TANDON
TM362
ART 186043-002 REV:A
FAB 186042-002 REV:

1:6401-001	T.M.342	DATE	1-2-68	BY	YJ	CHK	YJ	APP	YJ
Tandon			SCHEMATIC						
			P.A. T.M.302						
			1:6401 v.v.1

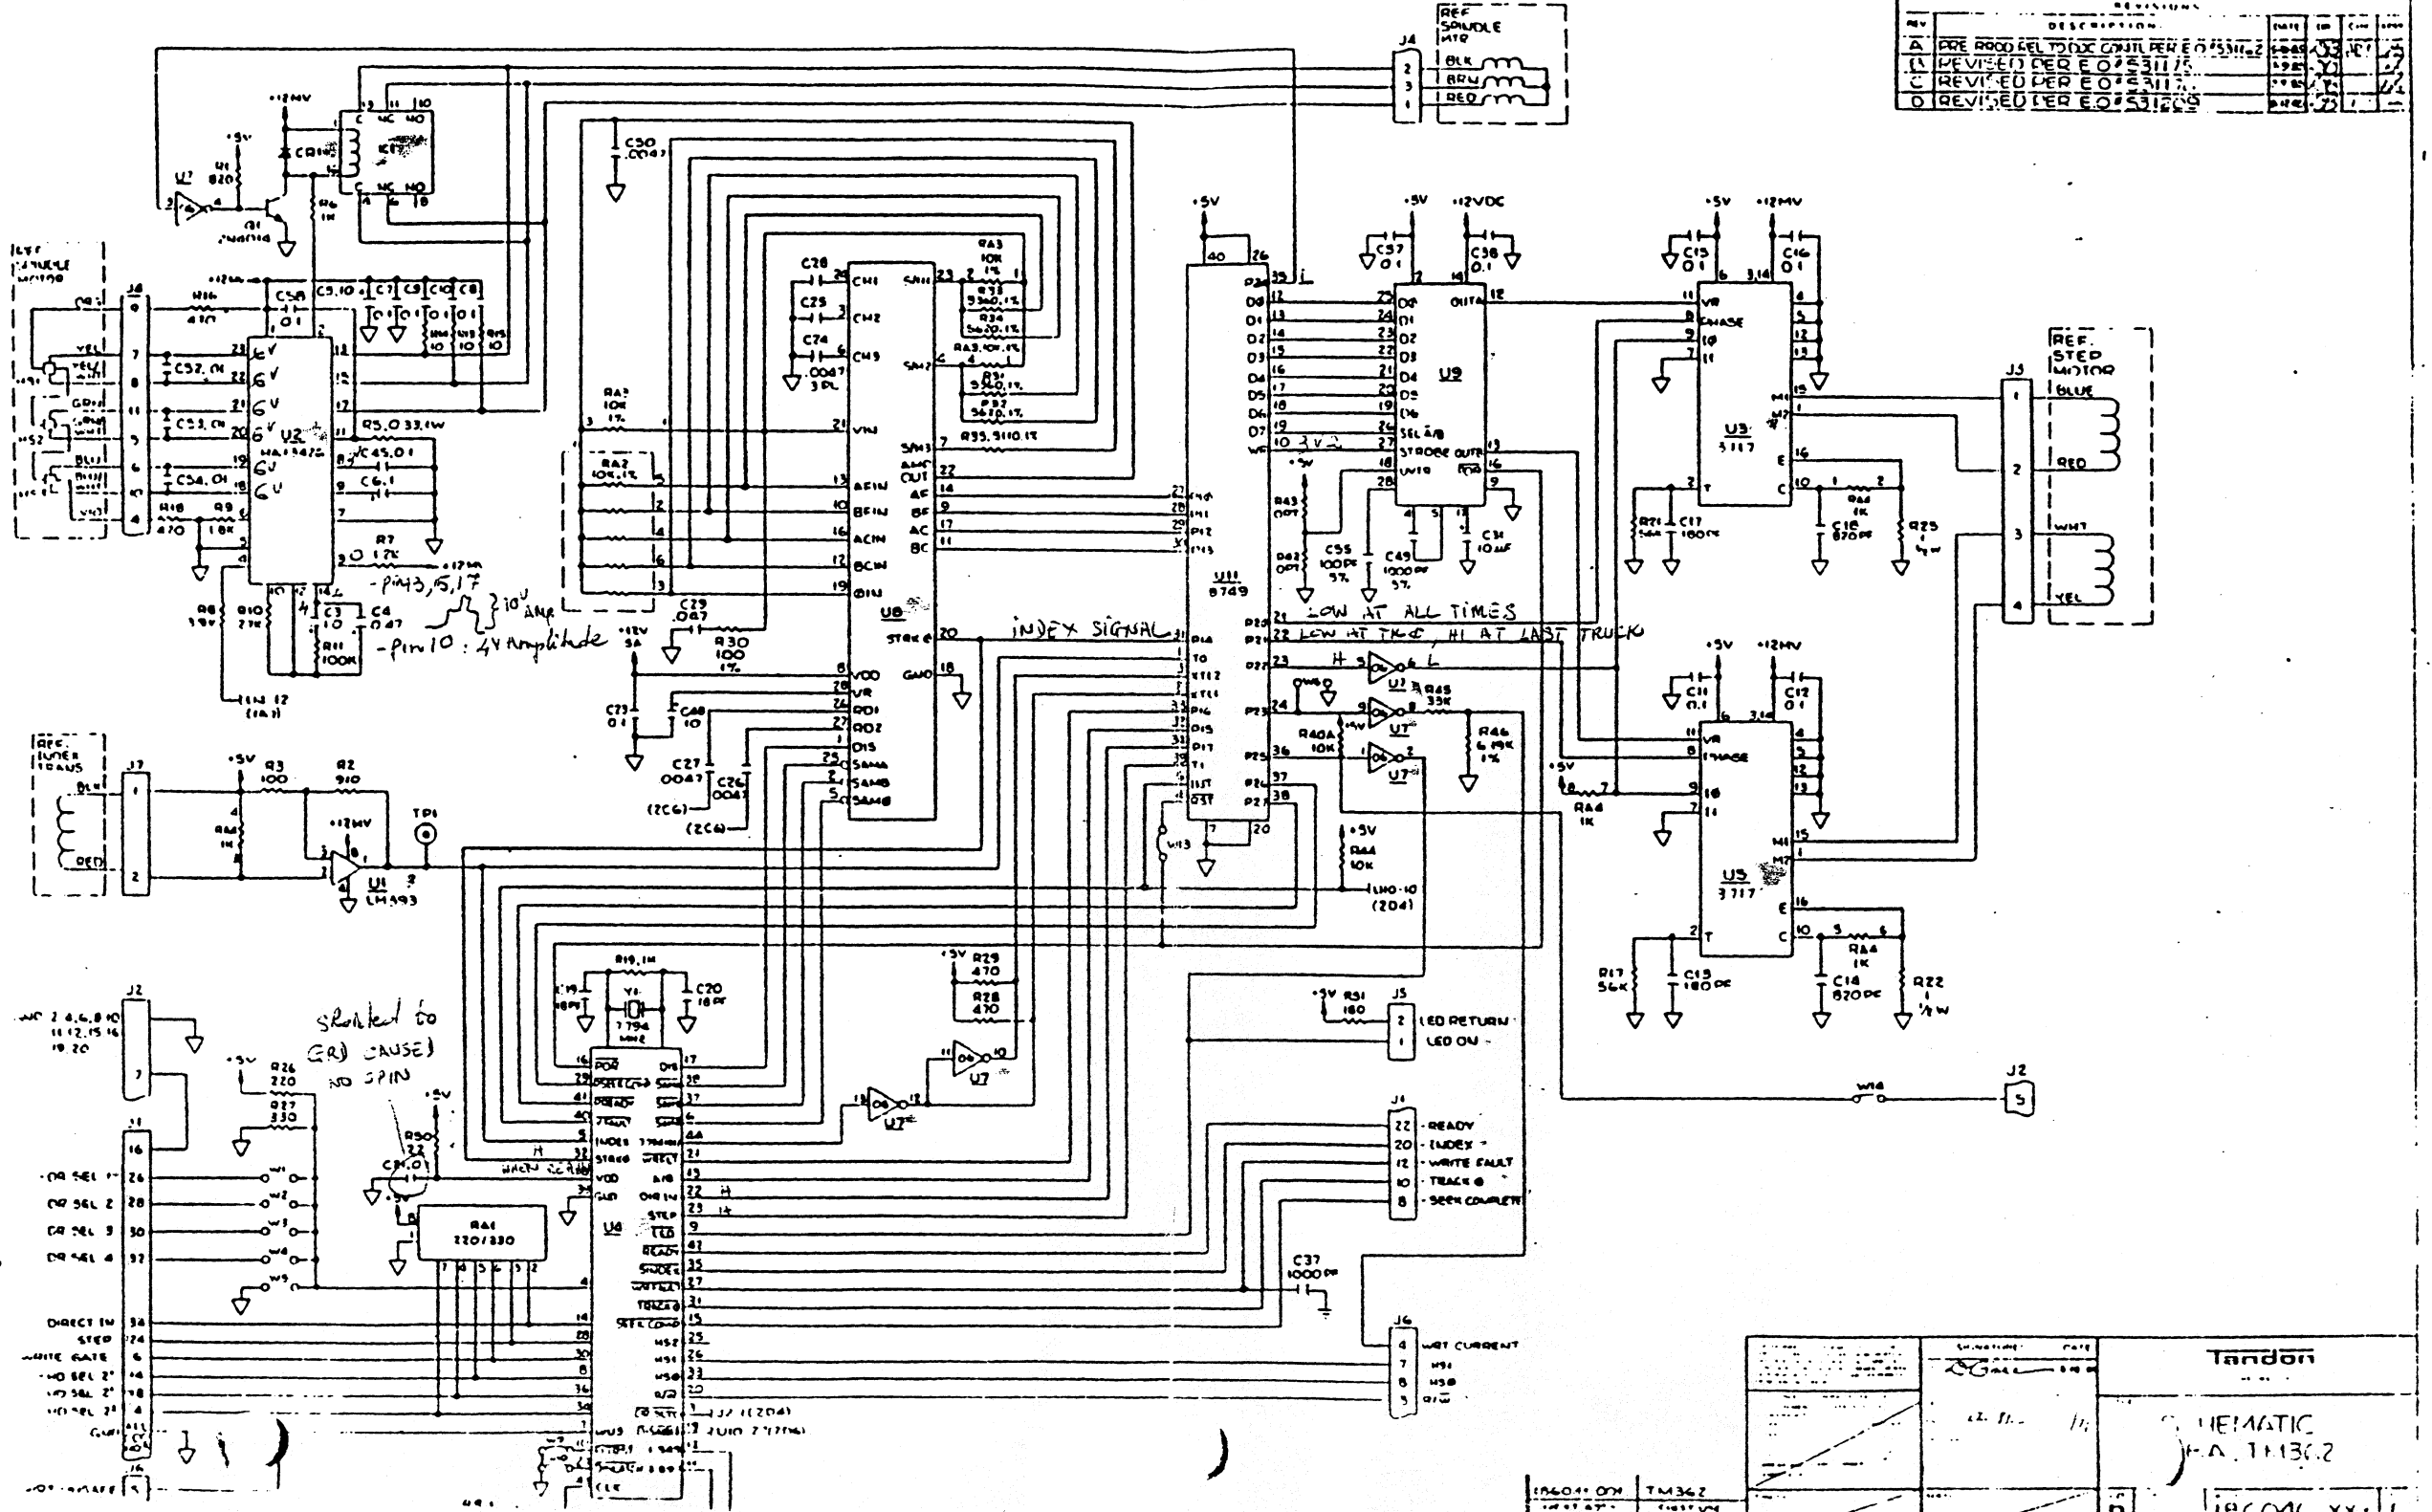
skipped to (CR) CAUSE NO SPIN

LOSES SPIN V U5, U3, U4
 U4: FIXE STEP TIME OUT FR WILSON

612 cyl.
 4 HD

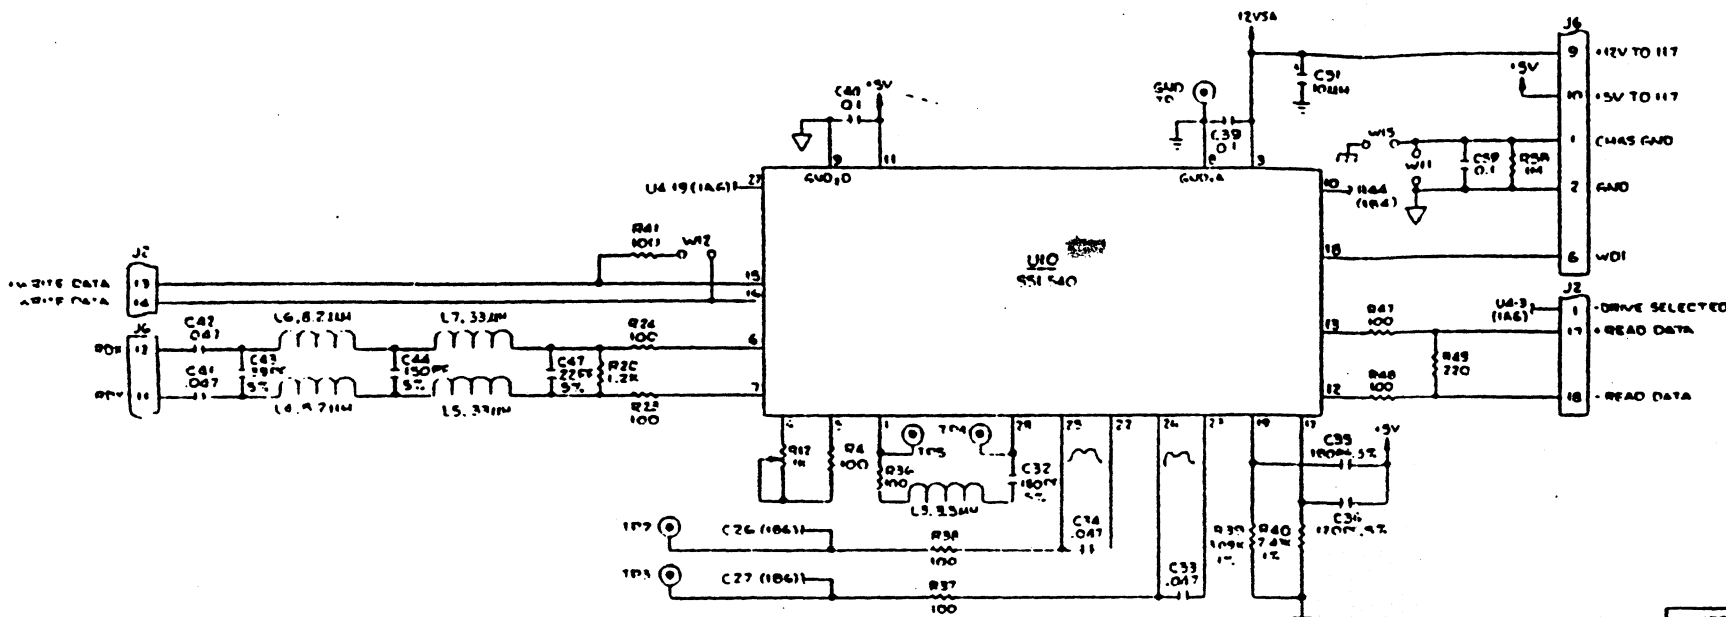
HD SIGNAL AT THESE POINTS HAVE TO BE EQUAL IN PAIRS AT BOTH ENDS OF C34, C33, 00 WILL HAVE R/W PROBLEM
